Product Change Notice (PCN)

PCN Number: PCN-0450904R-01

SJ1-42534-SMT-TR, SJ1-42535TS-SMT-TR, SJ1-42536-SMT-TR

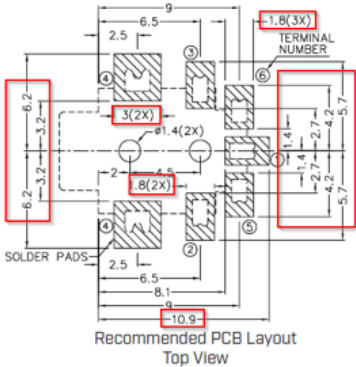
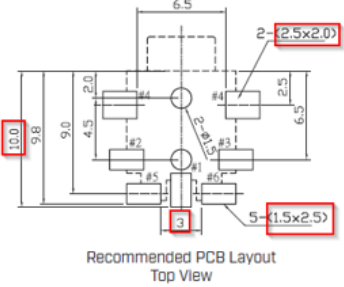
1. Minor dimension differences

PREVIOUS CUI DEVICES DETAIL / IMAGE	NEW CUI DEVICES DETAIL / IMAGE
 <p>Recommended PCB Layout Top View</p>	 <p>Recommended PCB Layout Top View</p>

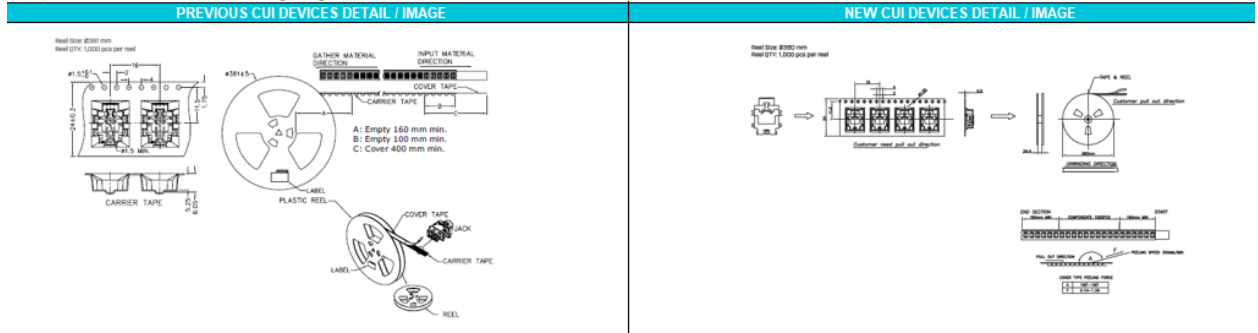
2. PCB pad size differs
